INITIAL FIRE SAFETY INSPECTION REPORT

ANANTA GARMENTS LTD (EXTENSION)

RSC ID: 26653

Date: 06-May-2026

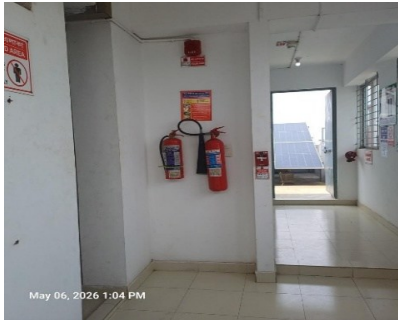
F-03	Means of Egress	Storage areas and similar normally unoccupied spaces discharges directly into the exit stair enclosure. Location(s): 2nd floor, Utility Building.	Openings from exit enclosure to Storage areas/ basements/ transformer rooms/ generator rooms/ boiler rooms and similar normally unoccupied spaces shall be provided with a vestibule with fire rated construction and openings in accordance with section 6.14.3 of RSC Technical Guidelines (Standard)¹ V1.0. Provide a min 1-hr fire rated door on the exit stair side and a 1.5 hr./1-hr fire rated door on the Store, generator, sub-station room side . Ensure that the fire rating of the vestibule construction matches that of the exit stair enclosure as per RSC Technical Guidelines (Standard)¹ V1.0. section 6.14.3. The minimum width for vestibules shall not be less than 1.1m and length 1.8m.	Within 3 Months

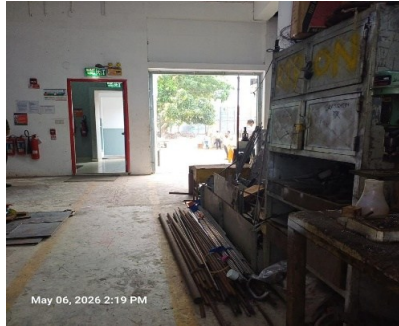
F-05	Means of Egress	Doors in the means of egress do not have the required minimum width. (Available Width: 35 in.) Location(s): All exit doors, Utility Building.	Doors in a means of egress shall have a minimum width of 1 m (39 in.). in accordance with section 6.5.6.1 of RSC Technical Guidelines (Standard)¹ V1.0.	Within 1 Month

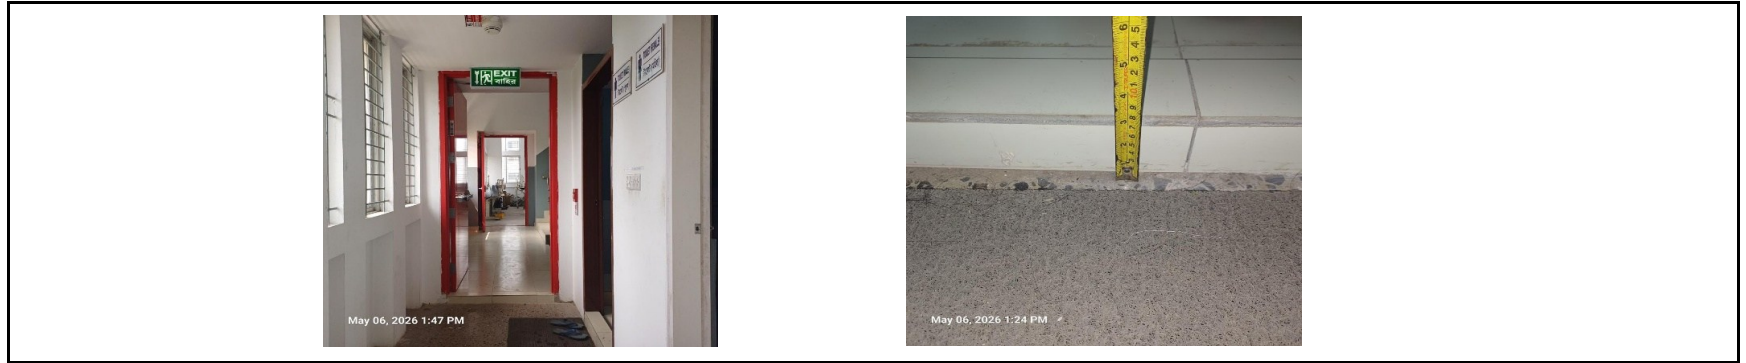
F-07	Means of Egress	Based on the number and location of emergency lights observed, adequate illumination levels are not anticipated along egress routes. Location(s): Several location of floors, Utility Building.	Test the emergency lighting system on each floor and provide additional emergency fixtures to provide adequate illumination along the means of egress. Provide a minimum illumination of 10 lux at the floor level within exit stairs and exit discharge paths, and minimum 2.5 lux along exit access aisles. Illumination on means of egress shall meet in accordance with RSC Technical Guidelines (Standard)¹ V1.0 Section 10.12.2.	Within 3 Months
		 May 06, 2026 2:17 PM	 May 06, 2026 1:52 PM

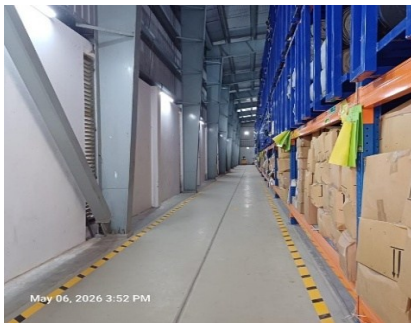
F-21	Fire Alarm & Detection System (FADS)	The factory has installed a fire alarm and detection system that requires a detailed review to confirm compliance with NFPA 72 and RSC Technical Guidelines (Standard). Few structures like Elastic and Embroidery shed, Elastic Shed, Security entry shed under monitoring through ID 9558 but fire alarm system connected with control panel which is under 26653. Additionally, 2 non-RSC structures (Prefabricated store shed-1, Carton store shed with different business license) connected with this control panel. So, the submission of initial design for ID 26653 shall be prepared to cover Elastic and Embroidery shed, Elastic Shed, Security entry shed and 2 non-RSC sheds. Location(s): Utility Building.	Submit the fire alarm and detection system design to RSC for review. Once the design is reviewed, install and modify the fire detection and alarm system throughout the building in accordance with review comment, RSC Technical Guidelines (Standard) and NFPA 72. After installation the owner shall conduct internal testing and commissioning and then contact the RSC for witness of final acceptance testing.	Design within 2 Months and modification/ installation within 4 Months
